CITY OF YORK
LOCAL PLAN
Site Selection Paper Addendum
September 2014

Non-Strategic Site Addendum **Page 19**

SUBMITTED SITE PLAN

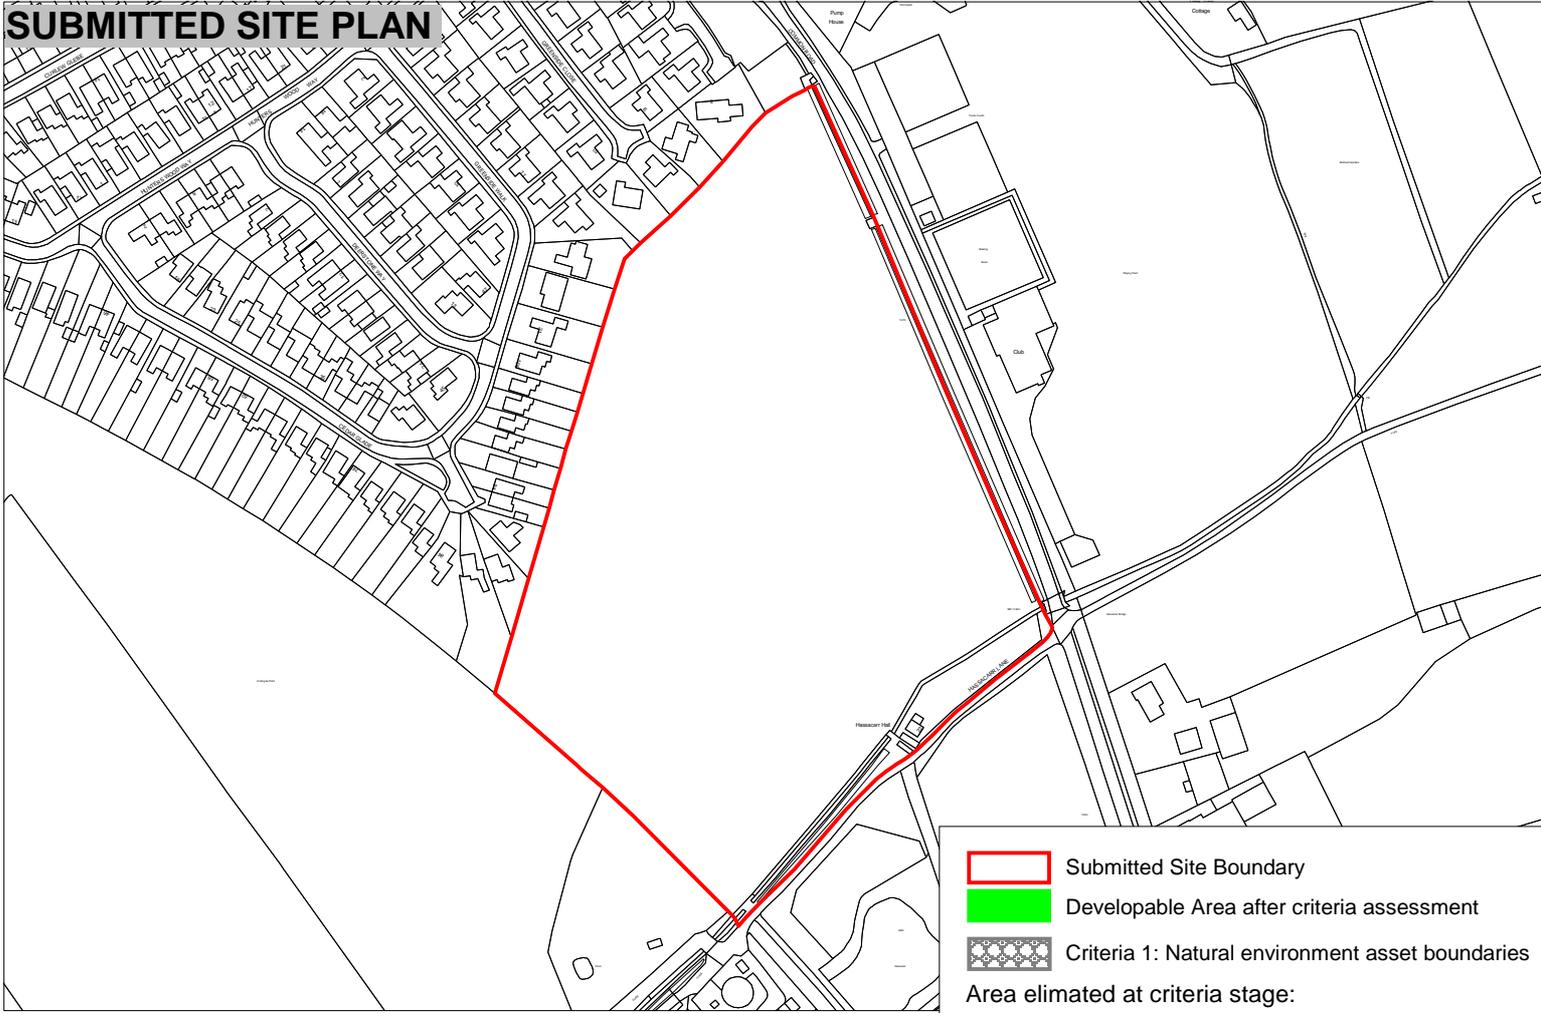
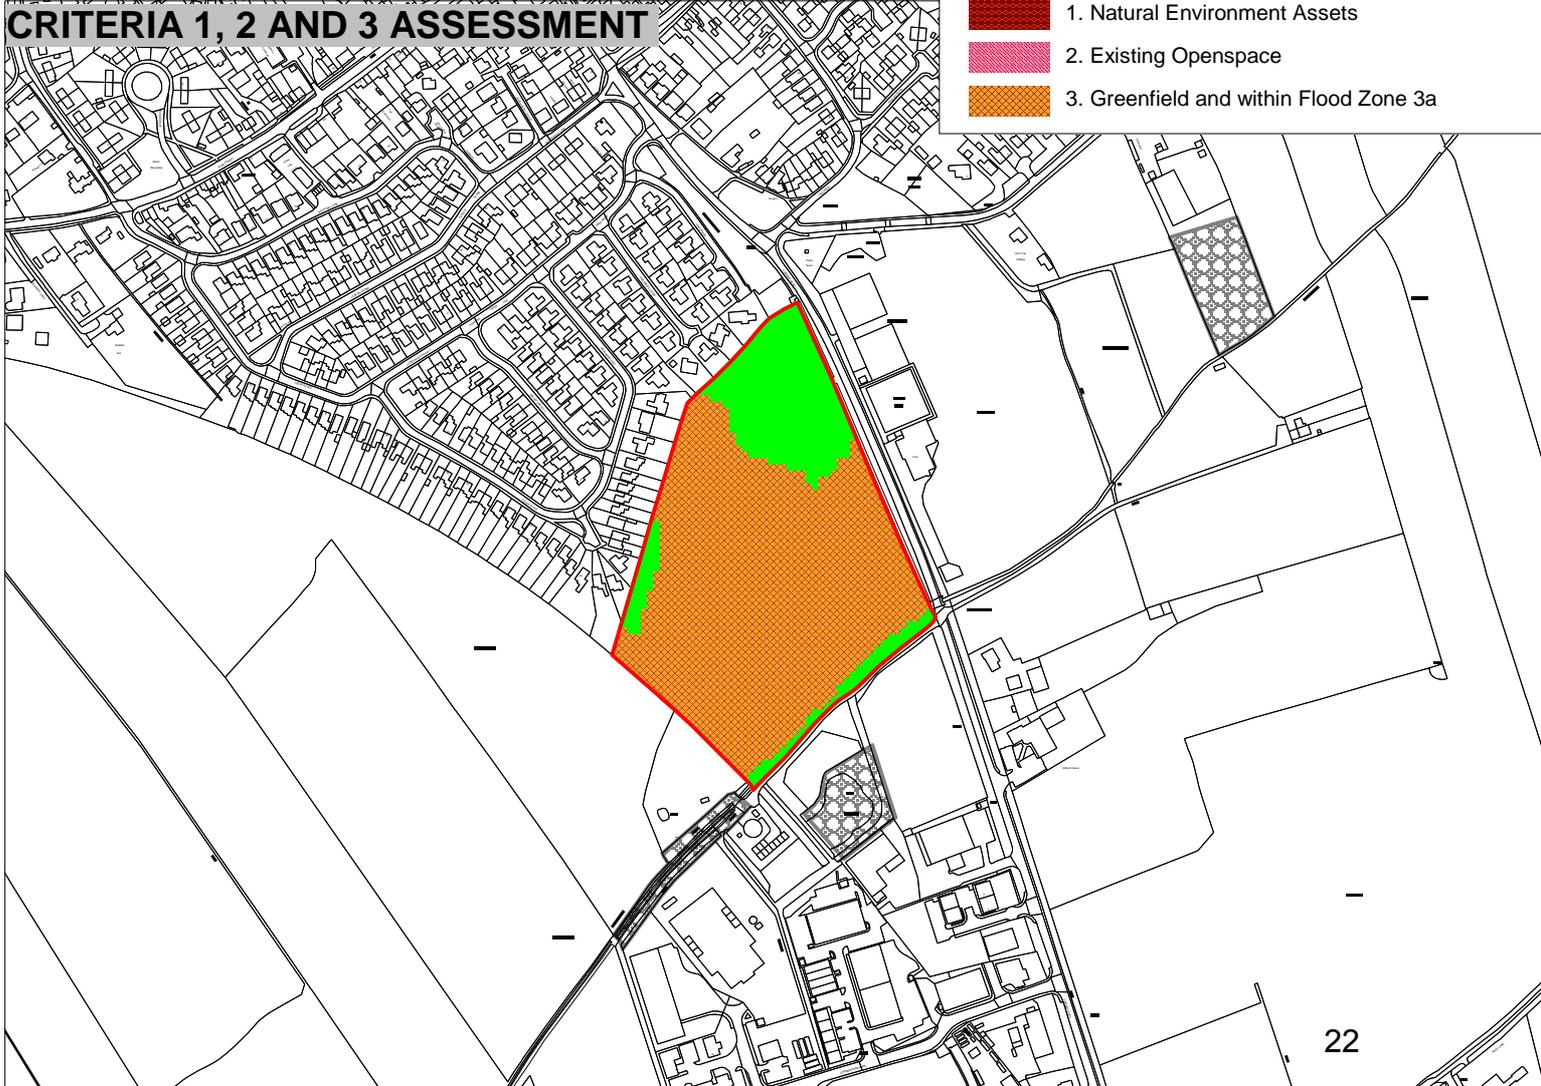
ID Ref:	ID6160
New site ref:	
Original Site Ref Number:	9
Allocation Ref:	
Site Name:	Common Lane, Dunnington
Submitted for:	Housing
Agent:	DPP One Ltd
Response submitted by:	Jon Brier
On behalf of:	Landowner
Additional Evidence Through FSC:	No
Summary of Response Received:	Object to rejection of housing allocation in FSC. Site was previously identified as an area of search for a gypsy and traveller site and therefore should be suitable as a housing allocation. Part of site is in flood zone 3 but development can be outside this and open space, gardens and ecological enhancement can be in flood zone 3a. FSC deletes the area of search for gypsy and travellers due to significant adverse impact on Dunnington village. No not agree that site would harm the character and setting of the village. Northwards from the A1079 the character and setting is industrial estate and therefore residential use would not affect the character. Southwards there is a backdrop of industrial buildings and landscaping would help to screen this and would not unacceptably harm the character and setting.

Archaeology Comments:	No further evidence submitted through FSC. An archaeological desk based assessment and evaluation will be required to identify archaeological features and deposits. AMBER
Retail Comments:	N/A
Proposals Map Action Required:	
Trajectory implications:	n/a
ID:	1
Officer Recommendation:	Site is not considered suitable as a housing allocation. A major part of the site is within flood zone 2 and 3a and there are major drainage and flood risk issues which remain a showstopper. The site was previously considered as an area of search for gypsy and travellers but this was on the basis that the areas of land within zone 3a would be used as grazing land for horses and not for residential use. The further work by consultants on the suitability, viability and deliverability of sites identified for gypsy, roma and travellers and travelling showpeople as consulted on in the FSC for this site considers that development in this location would have a significant adverse effect on the villages approach and setting and would be an obvious encroachment into open countryside. The significant screening and landscaping required to mitigate would also in itself impact on the character and setting of the area and is therefore not considered suitable. REJECT - NO CHANGE

SUBMITTED SITE PLAN

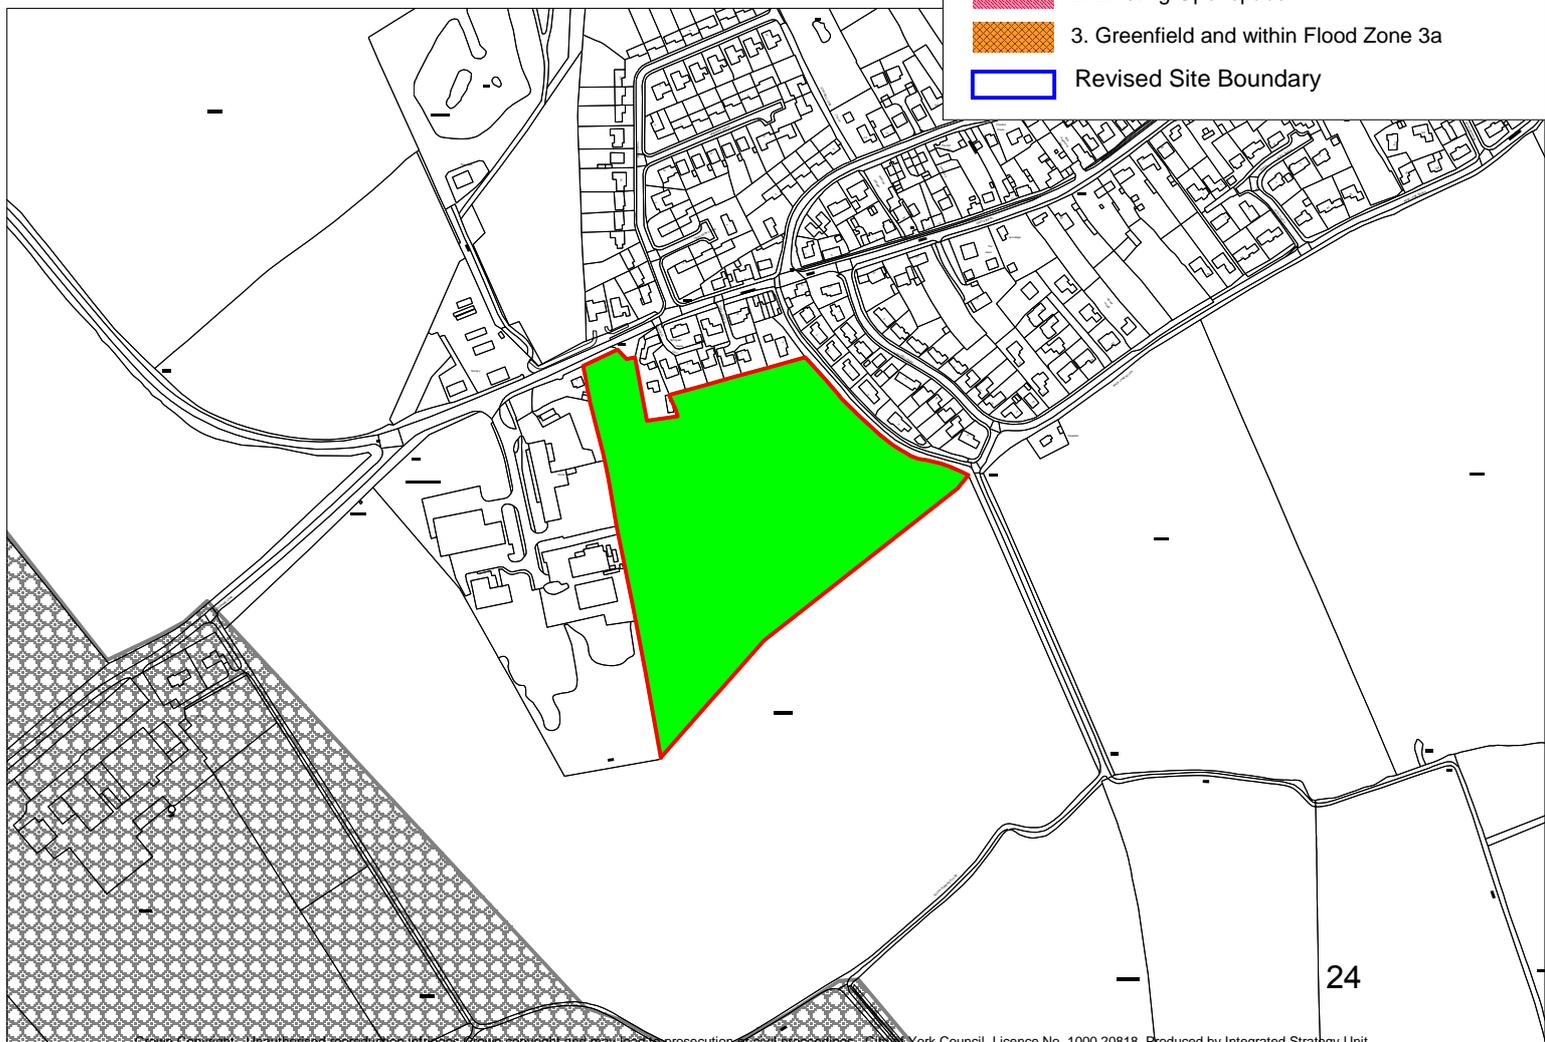
ID Ref:	ID10121
New site ref:	817
Original Site Ref Number:	13
Allocation Ref:	H49
Site Name:	Land at Station Yard, Wheldrake
Submitted for:	Housing
Agent:	Quod Planning

Response submitted by:	Hannah Smith
On behalf of:	Landowner
Additional Evidence Through FSC:	Analysis of criteria 4. Revised site map and masterplan
Summary of Response Received:	Object to rejection of site due to failing criteria 4. Meets greenbelt test. Logical extension to Wheldrake and would give defensible boundary to Wheldrakes southern settlement limit. Have amended boundary on western corner of site.
Flooding/Drainage:	Site is Greenfield therefore runoff rates must comply with the 1.4 l/sec/ha. This site is located in flood zone 1. Foul drainage runs through the site.GREEN
Landscape Comments:	No significant issues or constraints. GREEN
Ecology Comments:	Not aware of any significant issues or constraints. GREEN
Transport Comments:	No major concerns. Proximity to village facilities is acceptable. Cumulative transport implications with other allocations - need for assessment of public transport including the likely need to uplift bus services and the potential for achieving this uplift. AMBER

EDU comments:	N/A
Open Space Comments:	Open space assessment required. GREEN
Archaeology Comments:	This area forms part of the setting of the village particularly regarding access roads and is in close proximity to the conservation area. Newer built properties form the edge of the village to the east of this site. An archaeological desk based assessment and evaluation will be required to identify archaeological features and deposits. AMBER
Retail Comments:	N/A
Proposals Map Action Required:	Add to proposals map as housing allocation with amended site boundary
Trajectory implications:	Add to trajectory as new housing site
ID:	2
Officer Recommendation:	The site now passes criteria 4 (stage 2) after amended boundary submitted through FSC. Site is considered a suitable housing allocationThis site has previously been used as railway land, so land contamination could be present. The developer must undertake an appropriate assessment of the ground conditions and remedial work if necessary. This will ensure that the land is safe and suitable for its proposed use. Due to the proximity of the industrial estate a noise impact assessment will be required.Boundary change means site now passes criteria 4 and has passed technical officer comments. Site is considered suitable as a housing allocation

SUBMITTED SITE PLAN

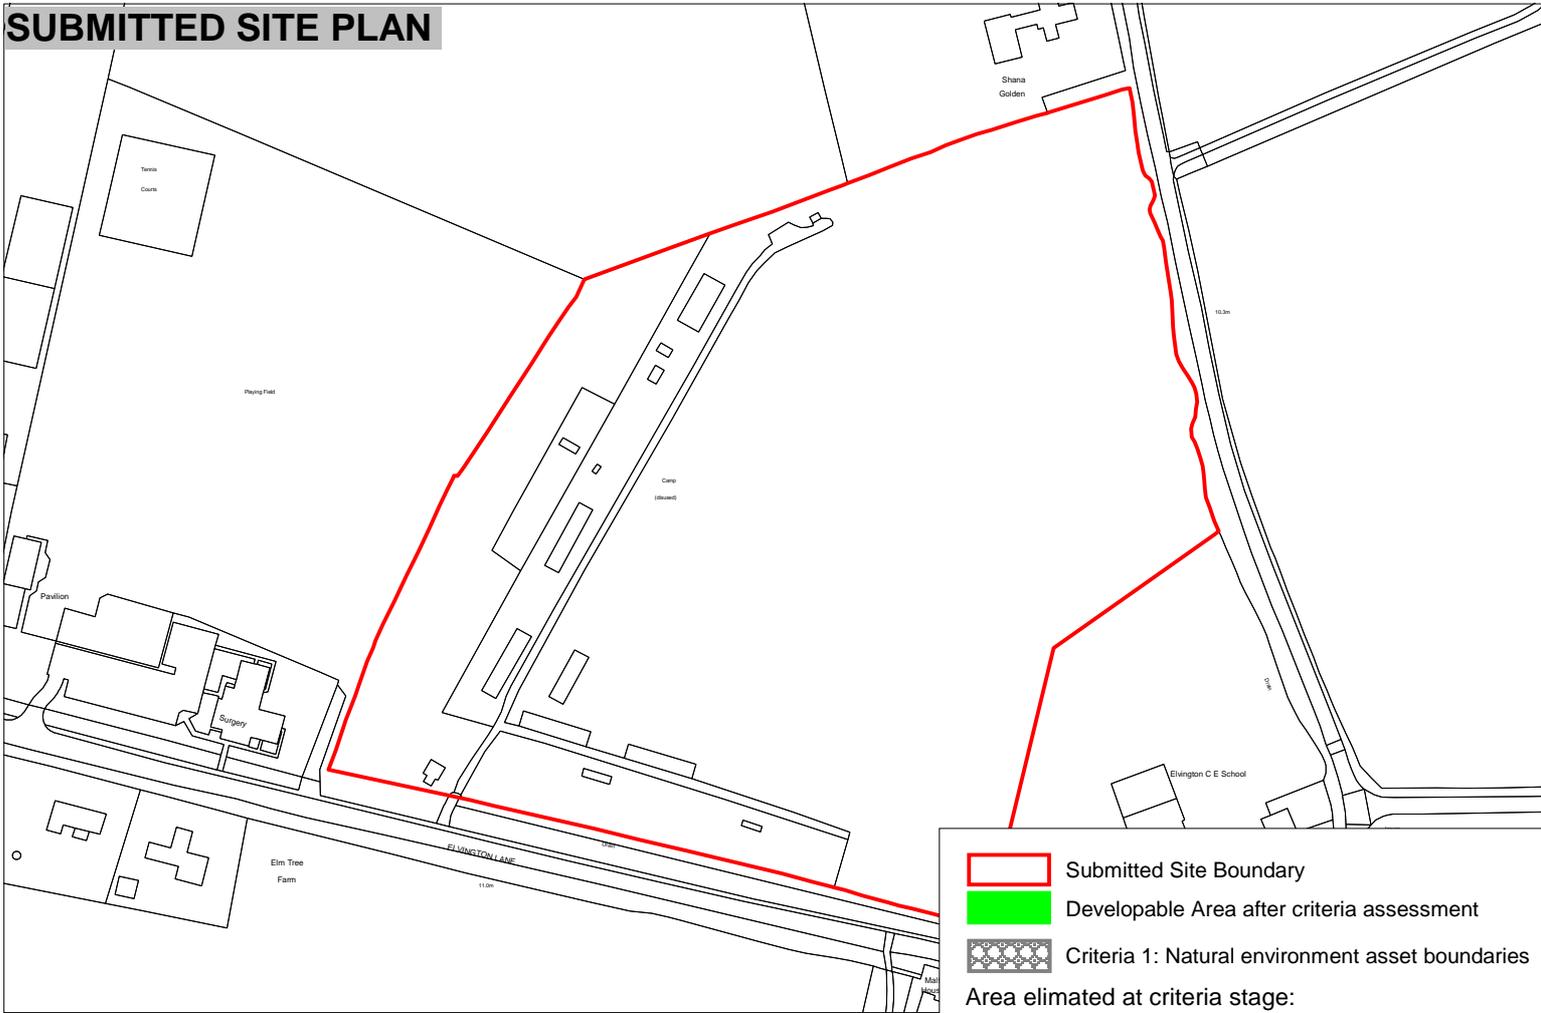
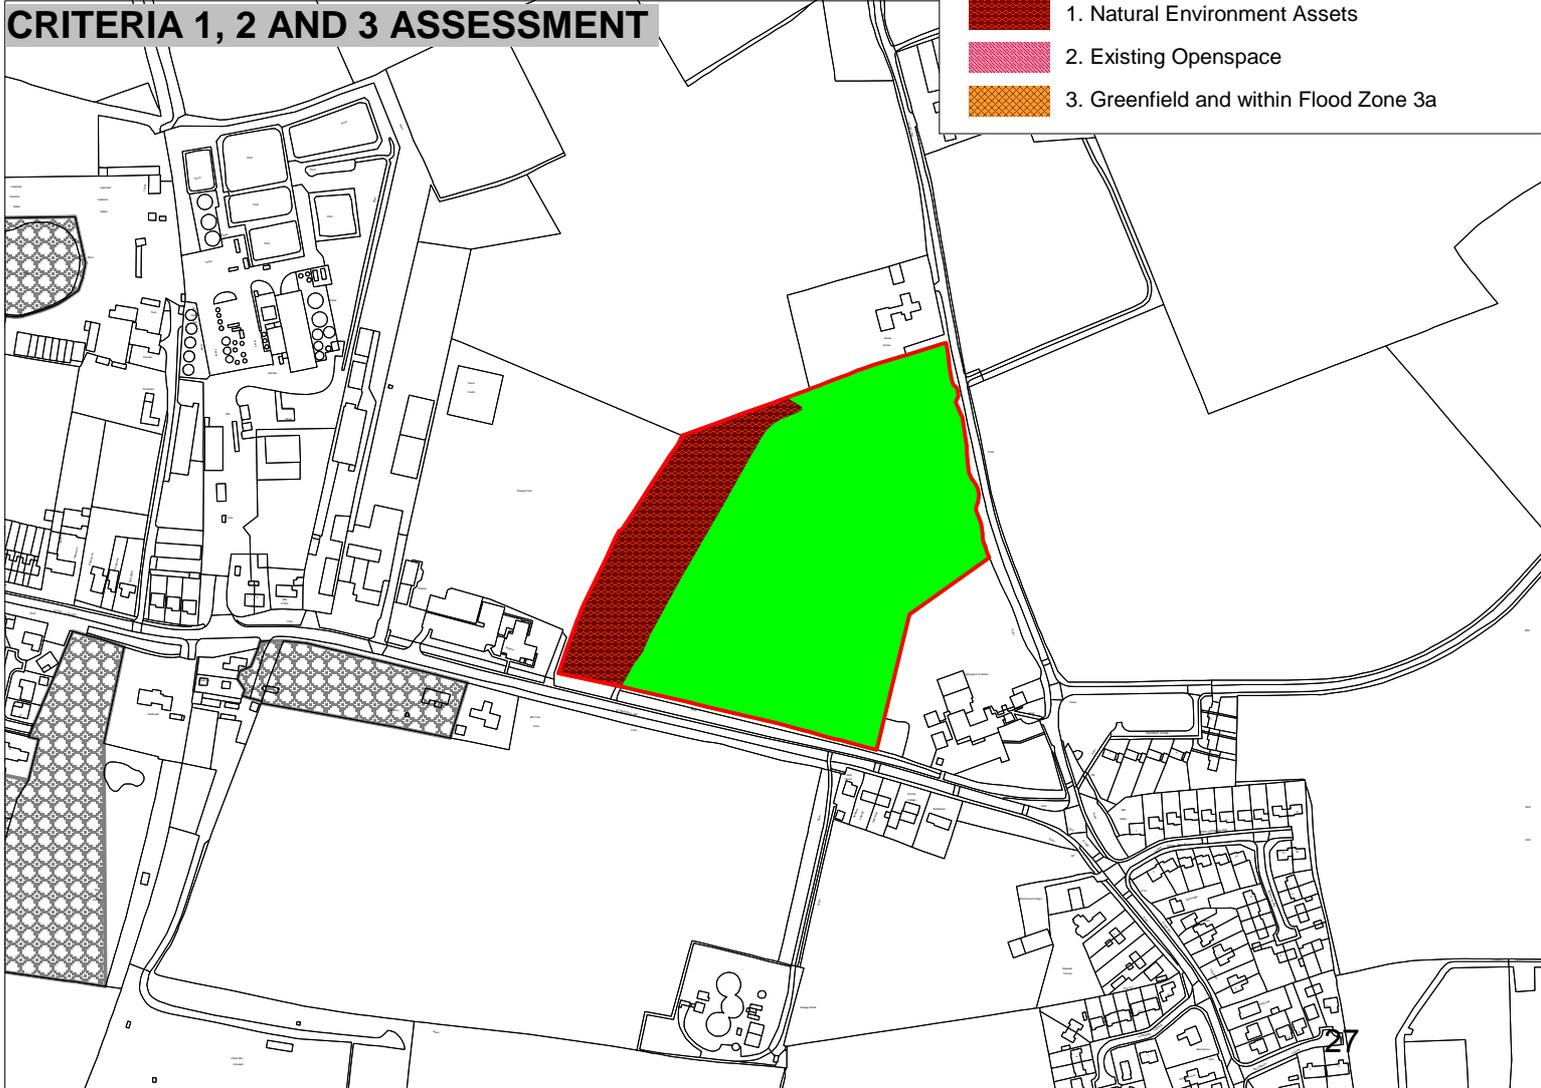
ID Ref:	ID9381
New site ref:	
Original Site Ref Number:	55
Allocation Ref:	H26
Site Name:	Land at Dauby Lane, Elvington
Submitted for:	Housing
Agent:	DPP
Response submitted by:	Mark Lane
On behalf of:	Linden Homes
Additional Evidence Through FSC:	Revised layout plan
Summary of Response Recieved:	Object to rejection of revised boundary in FSC. Exclude land to west of H26 put forward in LPPO. Land is designated SINC and subject to TPO's so is protected from development. Currently has limited value to community, better to create formal access into woodland with well designed footpath, willing to enter into ecological enhancement and management plan which could enhance SINC. New layout plan submitted which excludes development and demonstrates how inclusion will not harm ecological value of site
Flooding/Drainage:	No additional comment to FSC
Landscape Comments:	The parcel of land for development should continue to exclude the TPO and SINC site, and be treated as an independent quantity of land, rather than an opportunity to pass on open space requirements to beyond the development boundary. This is necessary to protect the integrity of the designations.

boundary of the allocation should not be extended to include the SINC. Red
Transport Comments:	No additional comments to FSC
EDU comments:	n/a
Open Space Comments:	No additional comments to FSC
Archaeology Comments:	n/a
Retail Comments:	n/a
Proposals Map Action Required:	Retain boundary of H26 as per FSC
Trajectory implications:	N/A
ID:	3
Officer Recommendation:	The site boundary of H26 should not be enlarged to include the land designated as SINC and containing TPO's. and be treated as an independent quantity of land, rather than an opportunity to pass on open space requirements to beyond the development boundary. This is necessary to protect the integrity of the designations. REJECT - NO CHANGE
